October 19, 2022

Dear Valued Parafilm Customer,

Two Layers into Roll

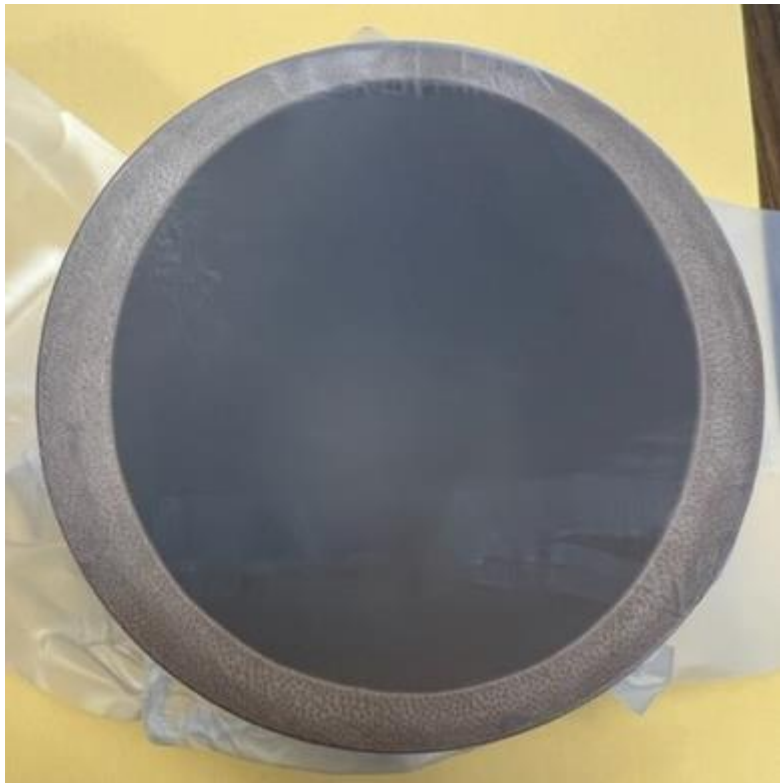
Recently our Parafilm operation has been upgraded from a manual process to an automated solution. The noticeable change in appearance, largely at the top of each roll, is due to our tail wipe system. As the rolls are taken off the line the unsecured end, or tail, must be secured for it to feed down our packaging line. To secure the tails, the finished rolls are spun against a stationary piece with free spinning indentation wheels while light pressure is applied. While this secures the tails, it also causes a visual marking on the material.

Past potentially the first wrap, this marking will be purely a visual defect and will not affect the functionality of the film. The pressure applied is not great enough to puncture the Parafilm to the point where functionality is affected past the first wrap.

Below are pictures of the tail wipe as well as the visual defects you might be seeing on some of the rolls you receive. We understand that the visual appearance is not ideal; however, it will not affect the functionality of the film itself past the first few wraps as you will see below. Please reach out if you are having additional questions on this.
